EC38–06/07

Tables 402.1.1 and 402.1.3; IRC Tables N1102.1.1 and N1102.1.2

Proponent: Charles C. Cottrell, North American Insulation Manufacturers Association (NAIMA), representing same

**Table N1102.1
INSULATION AND FENESTRATION REQUIREMENTS BY COMPONENT^(a)**

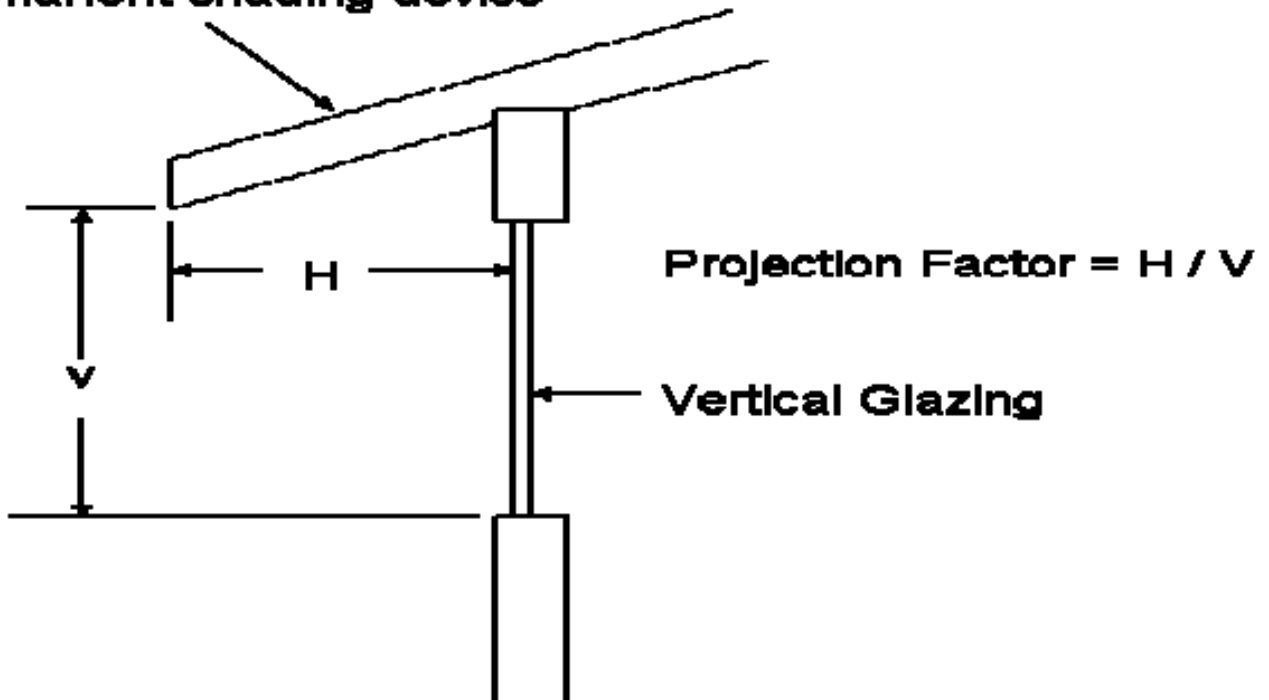
1. Revise table as follows:

Reason: This proposed code change also allows for the use of overhangs to meet the solar heat gain coefficient requirements within the IECC. Overhangs are considered permanent exterior shading devices and are allowed to be used in IECC Chapter 5 as a prescriptive trade-off to meeting

CLIMATE ZONE	FENESTRATION U-FACTOR	SKYLIGHT ^b U-FACTOR	GLAZED FENESTRATION SHGC ^b	CEILING R-VALUE	WOOD FRAME WALL R-VALUE	MASS WALL R-VALUE	FLOOR R-VALUE	BASEMENT ^c WALL R-VALUE	SLAB ^d R-VALUE & DEPTH	CRAWL SPACE ^e WALL R-VALUE
1	1.20	0.75	0.40	30	13	3	13	0	0	0
2	0.75	0.75	0.40	30	13	4	13	0	0	0
3	0.65	0.65	0.40 ^c	30	13	5	19	0	0	5/13
4 except Marine	0.40	0.60	NR	38	13	5	19	10/13	10, 2 ft	10/13
5 and Marine 4	0.35	0.60	NR	38	19 or 13+5 ^g	13	30 ^f	10/13	10, 2 ft	10/13
6	0.35	0.60	NR	49	19 or 13+5 ^g	15	30 ^f	10/13	10, 4 ft	10/13
7 and 8	0.35	0.60	NR	49	21	19	30 ^f	10/13	10, 4 ft	10/13

FIGURE 1: DAYLIT AREA UNDER SKYLIGHT

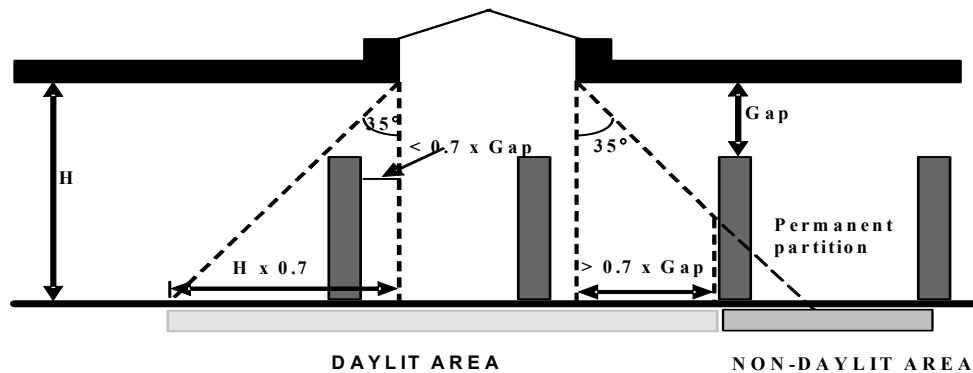
The area daylit by the skylight is that area directly underneath the skylight, and the perimeter area within 0.70 times the height between the floor below the skylight and the underside of the skylight, unless two or more skylights are close enough to each other that the 0.70 distance between them overlaps, or there is a permanent partition within the perimeter zone that is high enough to block the light from the skylight reaching some portion of the floor in what would otherwise be considered part of the daylit zone. Figure 1 explains how the permanent partitions could block daylight from some portion of the otherwise daylit area.

It should be noted that the proposed criteria resulted in an energy loss in only one of the configurations studied – in a warehouse equipped with one of the skylights studied in Seattle, when compared with the a similar building with glass skylights at 3% of the roof area, that met the current code criteria. In all other cases energy use and cost savings were achieved, and in many cases that energy cost savings exceeded 20 or even 30%.

DAYLIGHT ZONE:

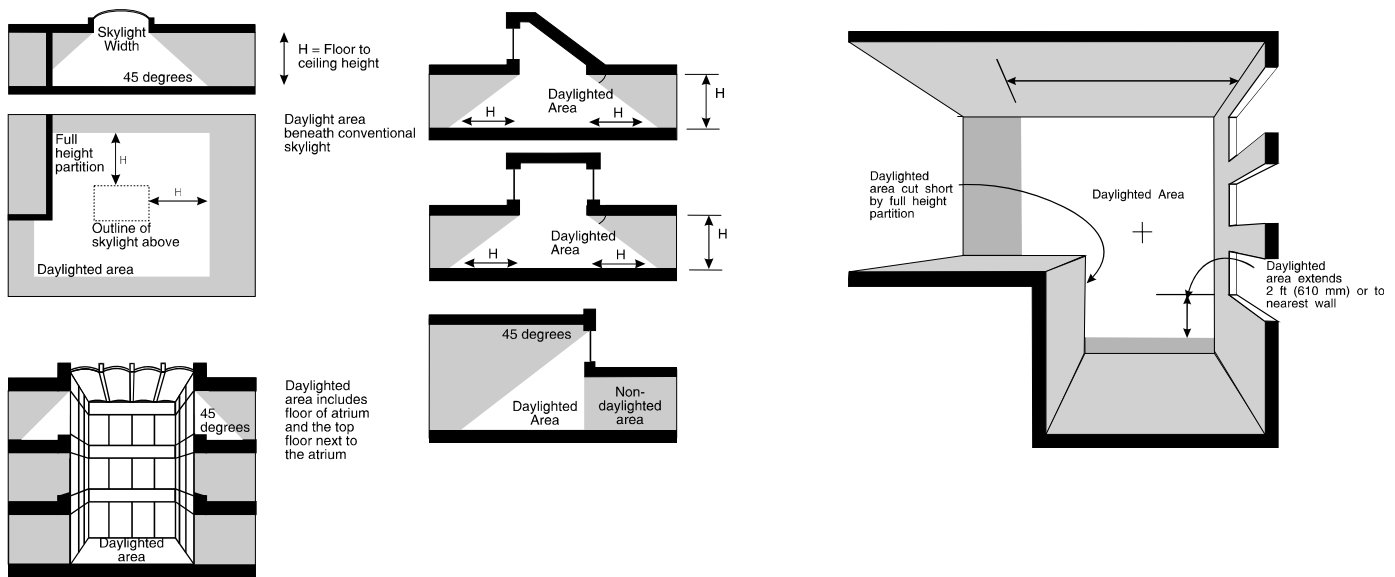
Add new text as follows:

1. **Under skylights:** The area under skylights whose horizontal dimension, in each direction, is equal to the skylight dimension in that direction plus either the floor to ceiling height or the dimension to a ceiling height opaque partition, or one-half the distance to adjacent skylights or vertical fenestration, whichever is least.
